Subcompartment Analysis
RWCU Line Break:
[Filter/Demineralizer Room]

In this paper, phenomena associated with a particular RWCU line break which is discussed in light of a recent River Bend Station (RBS) request to utilize the GOTHIC code for subcompartment analysis using a drop/liquid conversion model. A number of CONTAIN subcompartment calculations are presented to demonstrate the range of break room peak pressures that may be encountered with this class of subcompartment analysis based on water entrainment, de-entrainment, and slip ratios in exit pathways. Additionally, the appropriate assumptions for a conservative assessment of the RBS RWCU line break in the Filter/Demineralizer room are summarized.

Figure 7 Pressure calculations in the filter/demineralizer room for the 8 inch RWCU line break [SAR injection sources and SAR vent pathways].

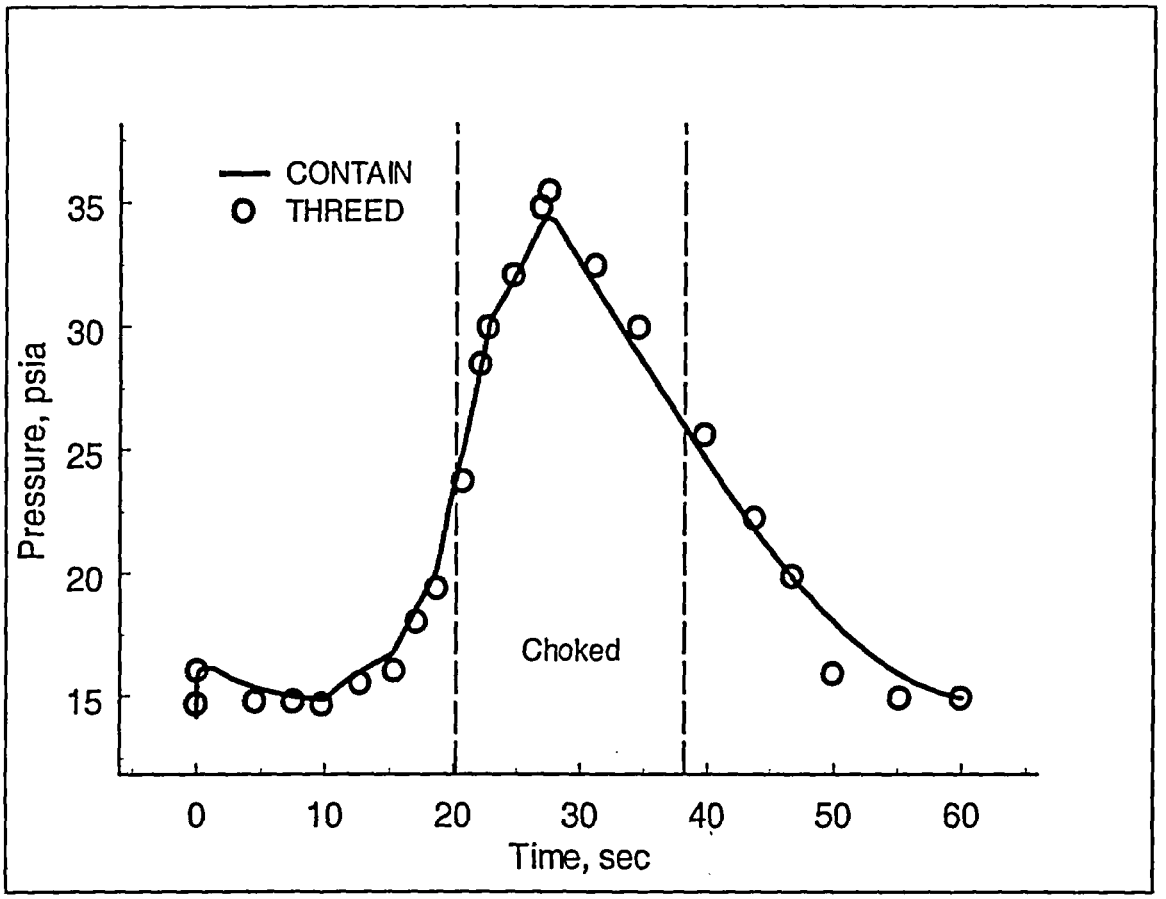
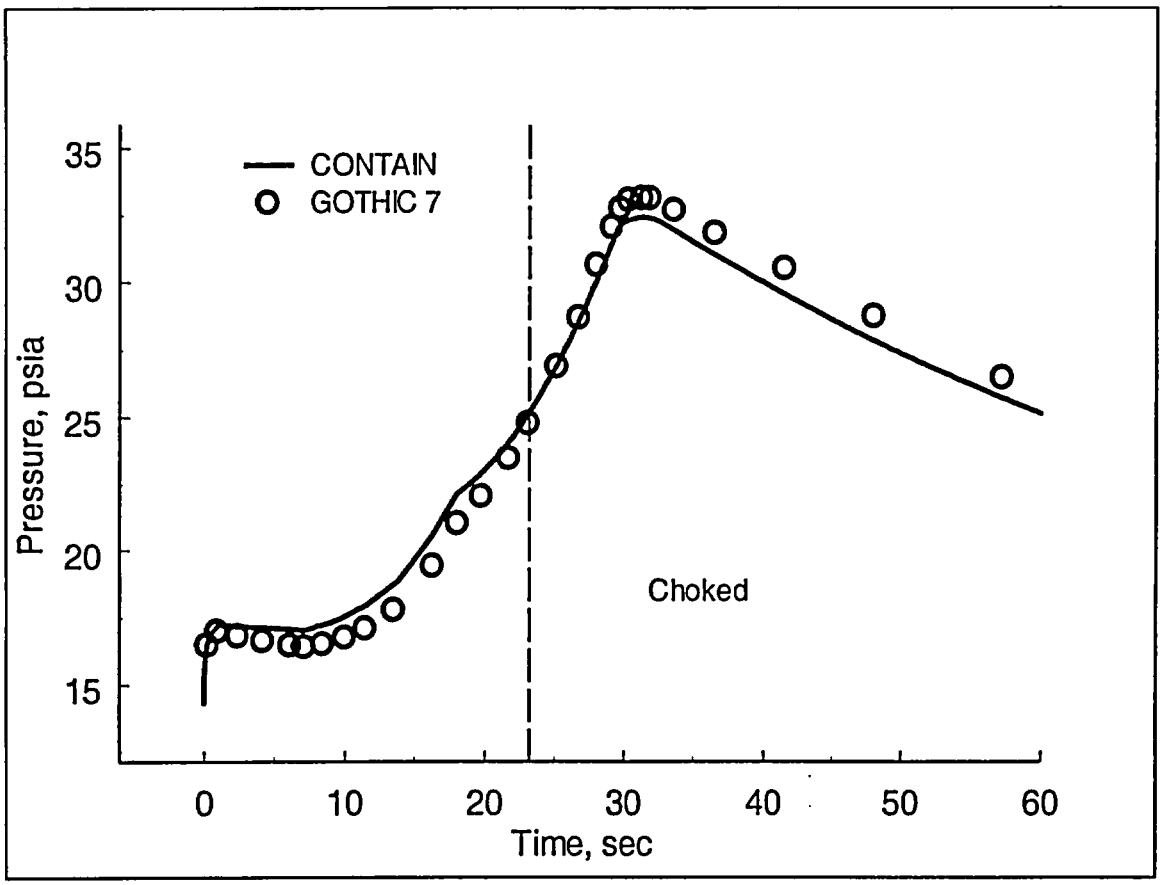
Benchmarking. Shown in Figures 7 and 8 are comparisons of the CONTAIN calculations for the RWCU line break in the Filter/Demineralizer room, with similar RBS code calculations performed with THREED (SAR) and GOTHIC 7 (new pathways and updated source), respectively. In the CONTAIN calculations, 100% entrainment of unflashed water is assumed, along with homogeneous flow through the pathways. Figure 7 shows that the CONTAIN and THREED code results are essentially identical. This confirms the original licensing basis and assumptions for entrainment and flow used in the RBS SAR. Figure 8 indicates that the CONTAIN results also compare favorably with GOTHIC calculations using updated break line sources and new vent pathways provided that the drop/liquid conversion model option is *not* used. Without the drop/liquid conversion model, the GOTHIC code appears to include models that force 1) 100% entrainment, and 2) homogeneous flow. Because the exit flows are choked in both the SAR and updated calculations (per CONTAIN result analysis), it would also appear that the critical choked modeling in all three codes, with S=1, are also similar. We note that the homogeneous frozen modeling (HFM) for critical choked flow in CONTAIN is scaled by input (recommended multiplier factor = 0.7) to approximate the homogeneous equilibrium model (HEM) used in both THREED and GOTHIC: the period of choking calculated by CONTAIN is shown in both Figure 7 and 8.

Figure 9 Break room pressure sensitivities for various subcooled liquid entrainment percentages for the 8 inch RWCU break in the filter/demineralizer room.

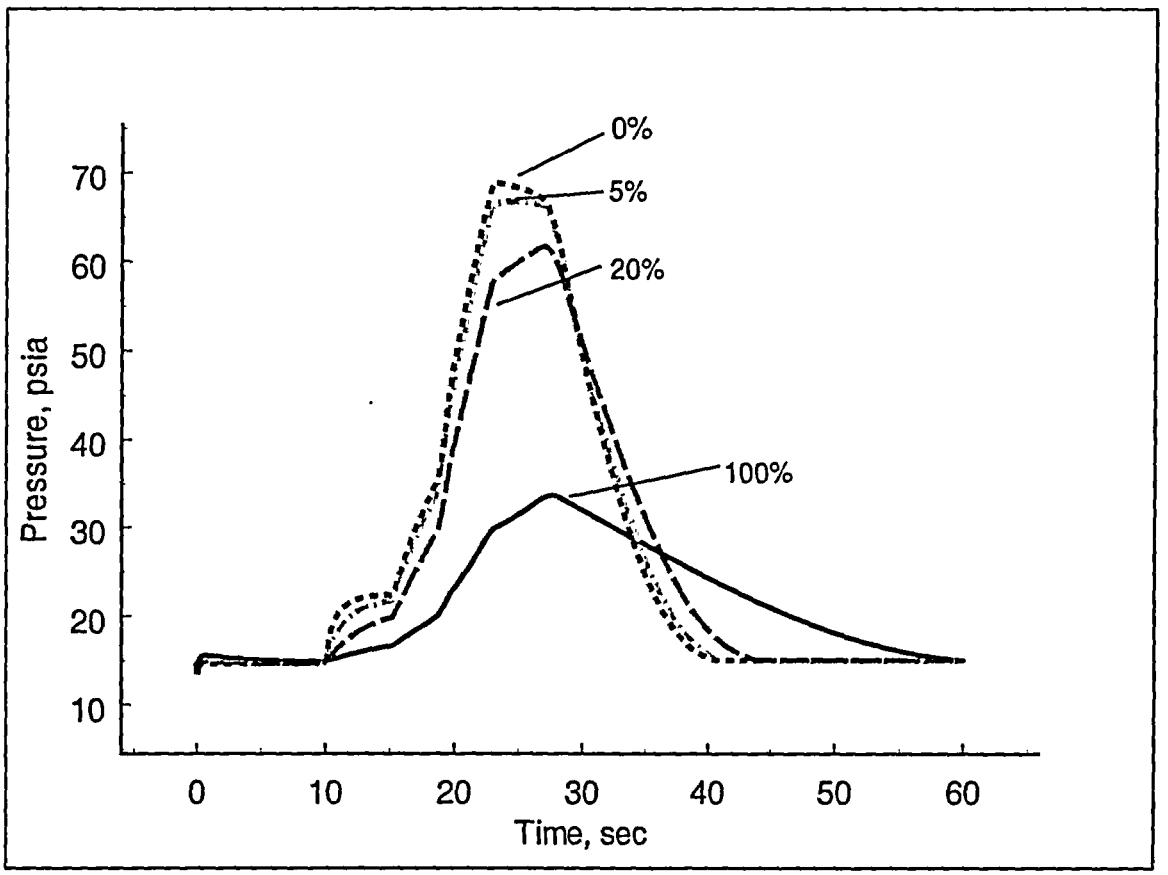
Subcooled liquid entrainment. The initial injection of subcooled liquid into the break room was assumed to have 100% water entrained into the free gas volume with no de-entrainment. Some breakup of the liquid jet could be expected due to mechanical or aerodynamic forces, but as noted above the assumption that 100% of the liquid is suspended would appear to be an overestimate, and nonconservative. Shown in Figure 9 are pressure profiles calculated assuming various entrainment amounts for the initial (10 second) injection of subcooled water. In these calculations, the liquid *flashing* jet, after

10 seconds, is assumed to be 100% entrained (as assumed in the benchmark exercise). These results from CONTAIN calculations show that peak pressure in the break room is very sensitive to the assumption of how much entrainment of the initial subcooled liquid water occurs.[4] From the discussion concerning subcooled liquid injections, it would be reasonable to select entrainment percentages significant below 100% for this early source of water. A conservative assumption would exclude subcooled liquid water as a possible entrainment source, locating this water into the sump of the break room.

Figure 11 Sensitivity of break room pressure for 8 inch RWCU line break to de-entrainment of unflashed liquid water injected after 10 seconds.

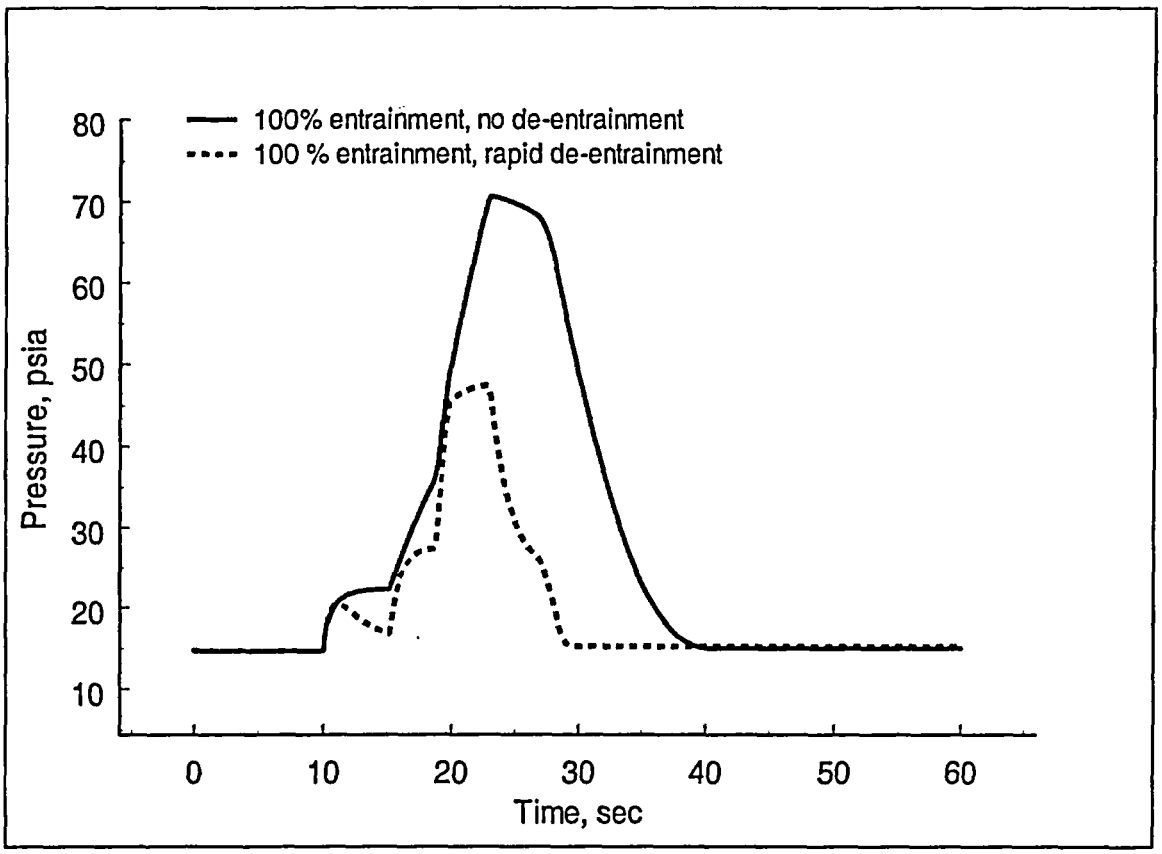
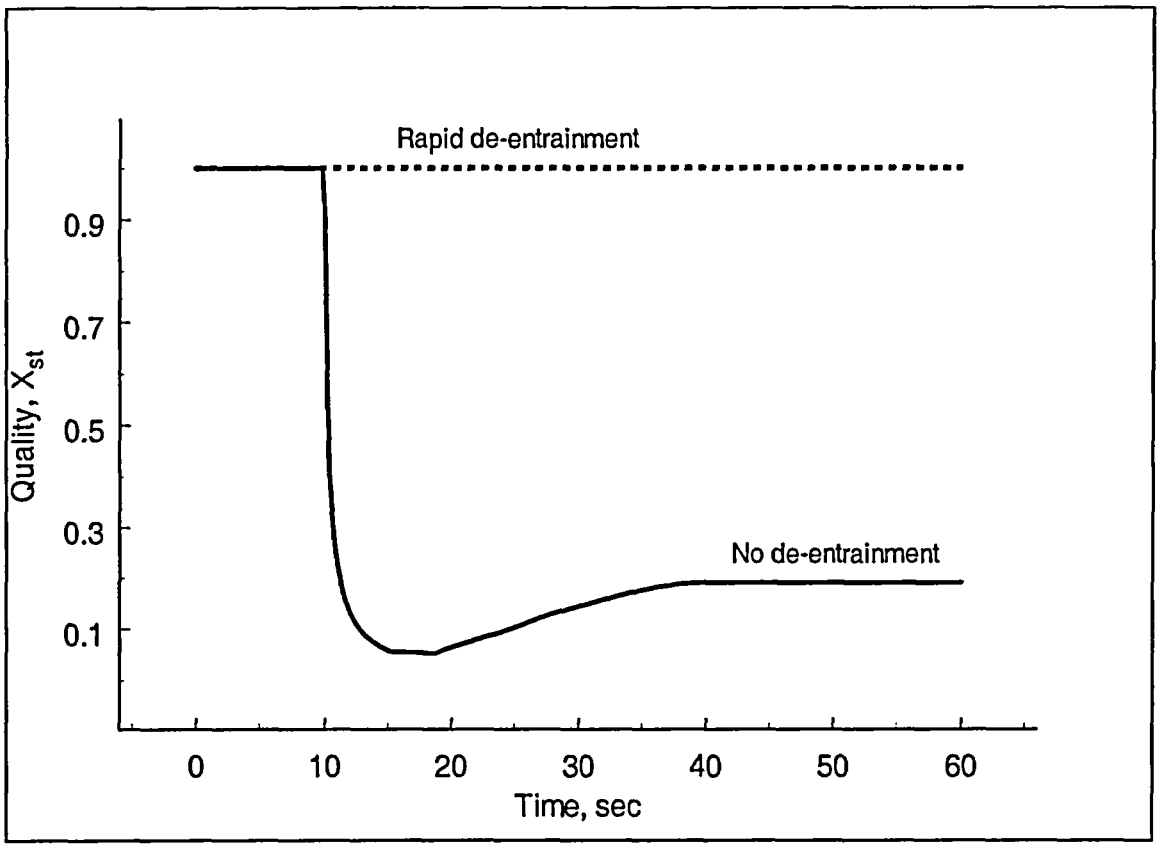
In the above flashing liquid calculations, the unflashed liquid entrained into the atmosphere is assumed to remain suspended throughout the accident. Of course some liquid will be de-entrained by some of the processes listed in Table 1. Shown in Figure 11 is a sensitivity calculation assuming an initial 100% entrainment of unflashed liquid water with subsequent rapid dropout (removal of liquid water at end of timestep). The gas/vapor quality in the break room is shown in Figure 12. The increased quality for the case with essentially an infinite deposition rate effectively increases the gas/steam mass flux through the exit pathway according to $G_v = X_{st}*G_m$. The low quality for the ~ zero deposition rate significantly reduces the gas/steam flow and therefore increases the peak pressure calculated for the break room.

Figure 13 Sensitivity of break room pressure for 8 inch RWCU line break to slip ratios. The solid line represent the case with homogeneous flow, S=1. The dash-dot line corresponds to a simulation of near infinite slip ratio.

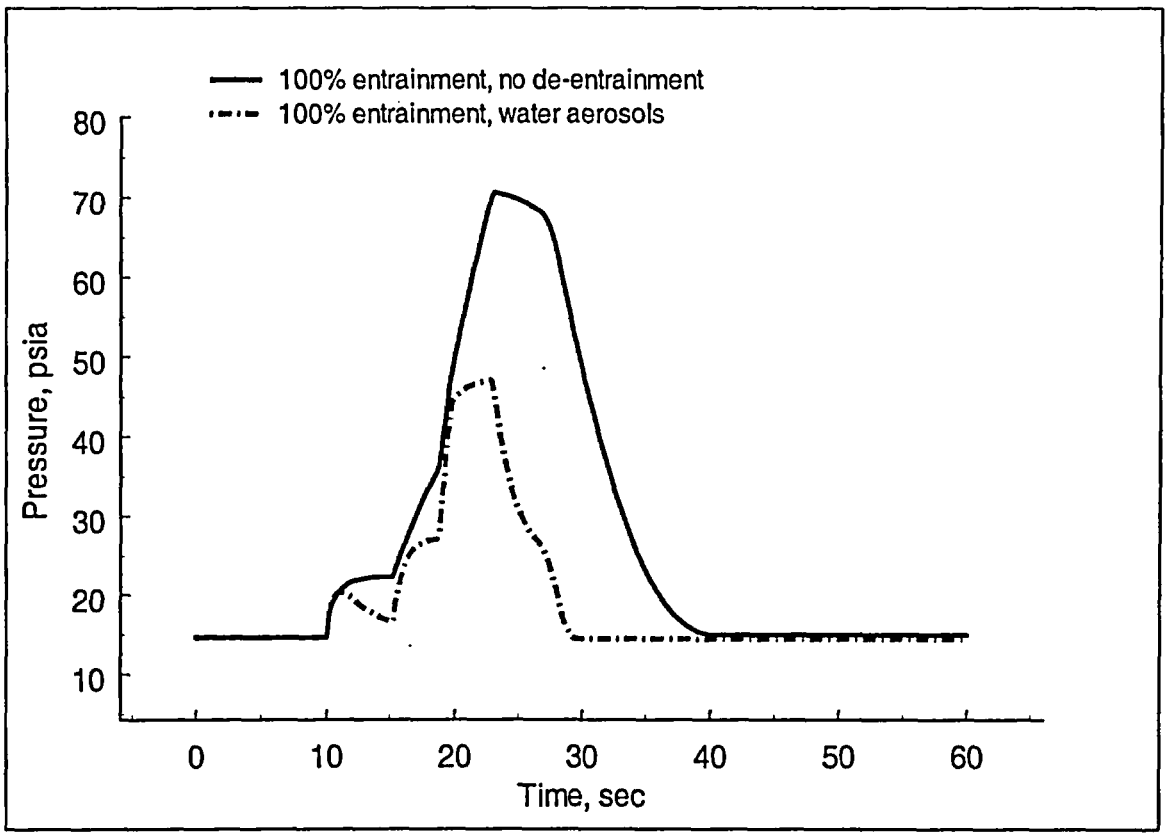
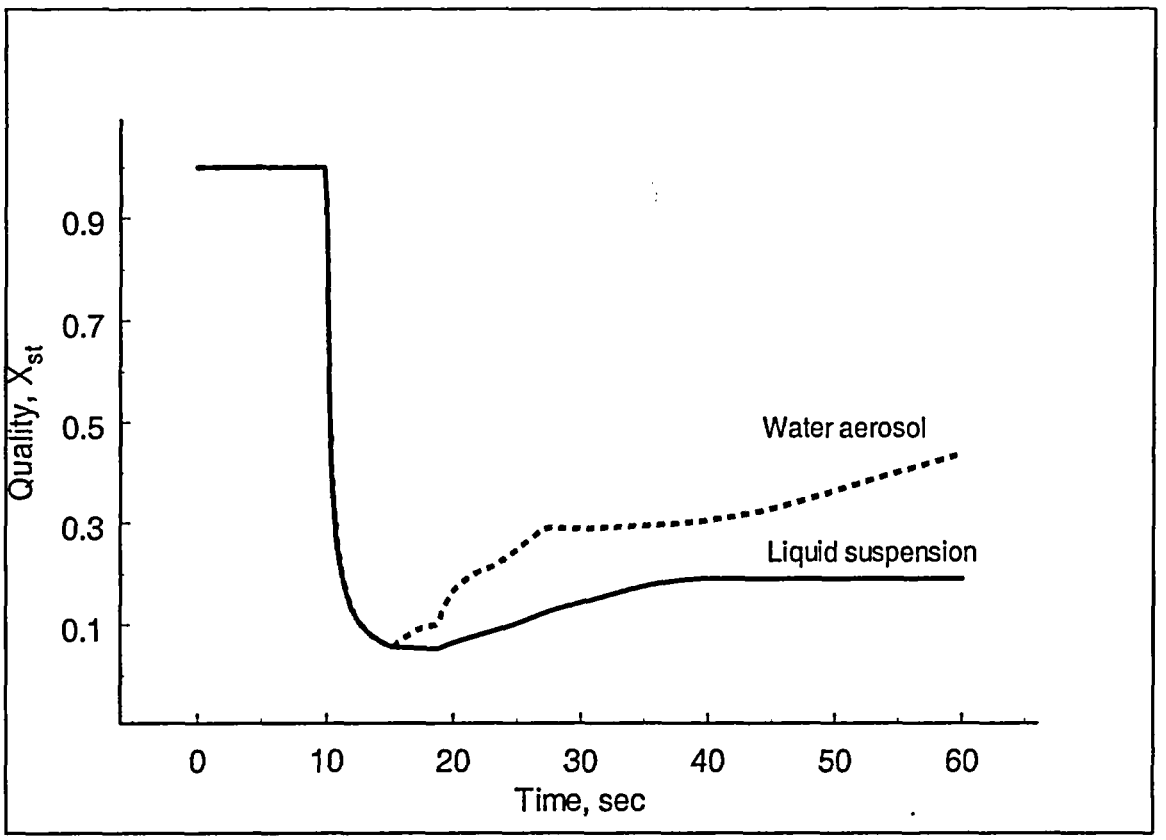
As we noted in the discussion on slip, if the slip ratio is increased the flow quality also increases. Therefore, at high slip ratios, the flow through the exit pathway is essentially all gas/steam. In CONTAIN, if the flashing liquid is injected into the break room atmosphere as an external water source along with liquid water aerosol generation, a simulation of near infinite slip ratio can be approximated. The infinite slip is effectively approximated since aerosol mass is not included in the homogeneous fluid density of gas/steam/aerosol mixture flowing through the pathway exit. By not including the

suspended liquid aerosol in the fluid density, an infinite slip ratio is simulated. Shown in Figure 13 is the pressure profile comparisons for 100% entrainment of unflashed liquid with liquid included in the fluid density ($G_v = X_{st}*G_m$), and the case with liquid excluded ($G_v = G_m$). The break room qualities, representing suspended water, are shown in Figure 14 (note: only for the case labeled "liquid suspension" is the quality factored into the calculation of gas/steam flow). Both methods have the suspended water in thermal equilibrium with the gas/steam mixture. It is interesting to note that the pressure profiles for aerosol suspension and the case with rapid dropout are essentially identical. These comparisons indicate that whether simulating rapid de-entrainment or ~ infinite slip ratio the cases result in similar break room pressures.[5]

Figure 15 Sensitivity of pressure profiles to exit pathway area for the filter/demineralizer during an 8 inch RWCU line break (SAR sources and pathways).

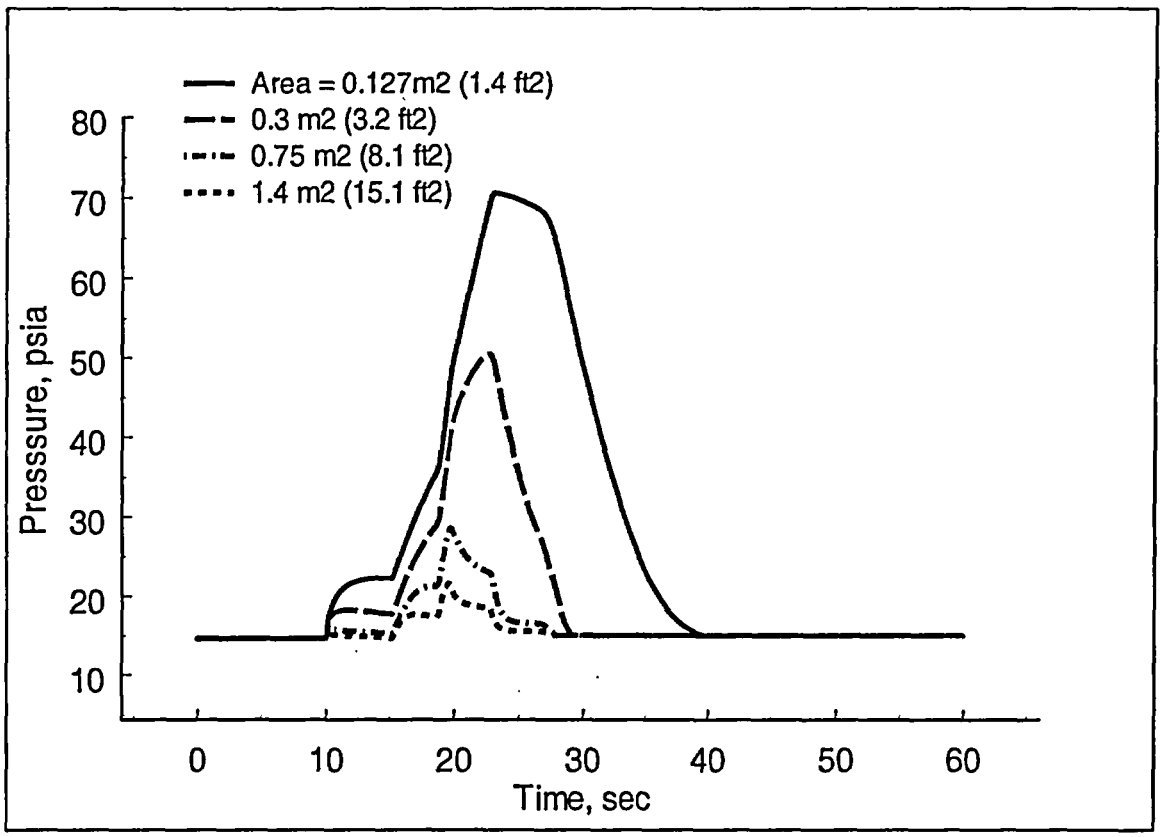
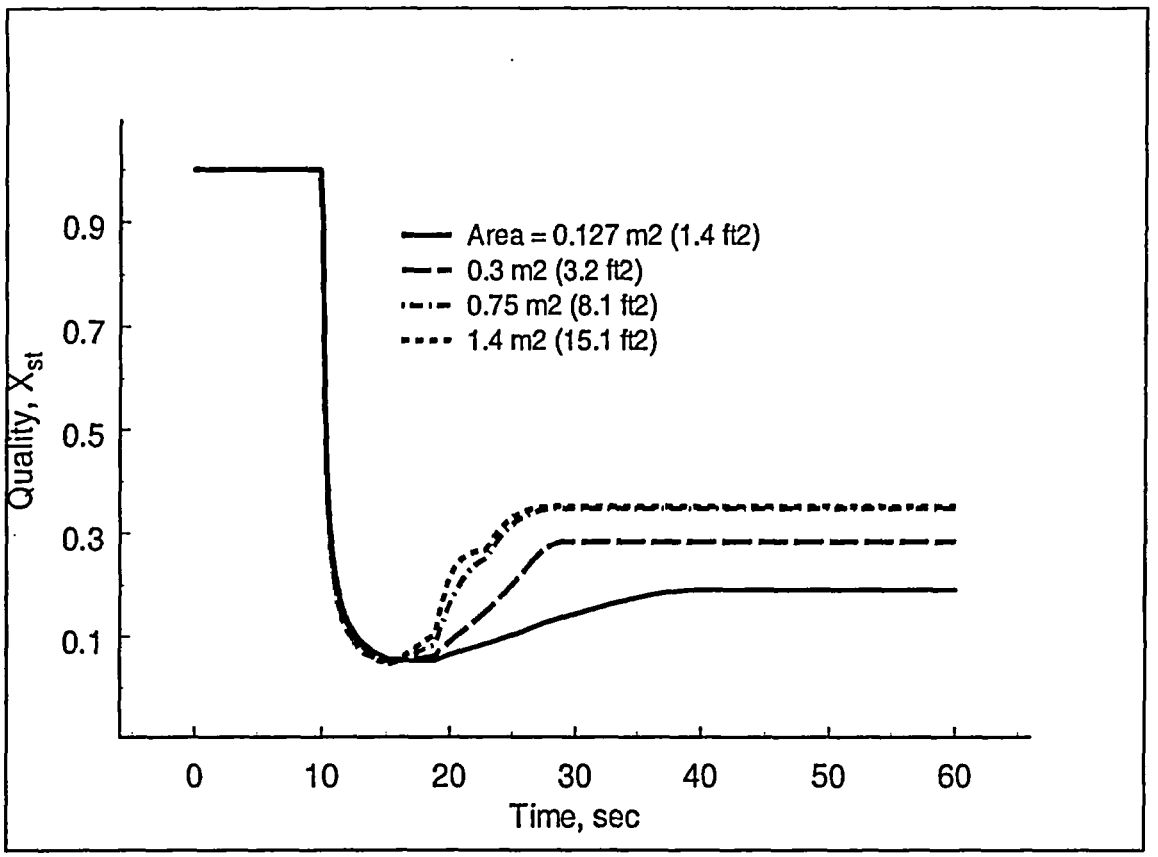
Vent pathway flows. The exit pathway area for the Filter/Demineralizer room, referenced in the RBS SAR calculations, is 0.127 m^2 (1.4 ft^2). This vent area is quite small, and notably smaller than similar vents for Filter/Demineralizer rooms in some other Mark III containments (~ 1.4 m^2 or 15.1 ft^2). Shown in Figure15 is a comparison of pressure profiles for the 8 inch RWCU line break for various exit vent areas. As indicated in the figure, very modest peak pressures are shown for vent areas that approach the 1.4 m^2 vent exit area. Figure 16 shows the quality profiles in the break room calculated for these vent areas. Note that these calculations are performed with the subcooled liquid directed to the sump and 100% entrainment of unflashed liquid water with no de-entrainment in the break room. The vent flow is modeled as homogeneous flow.
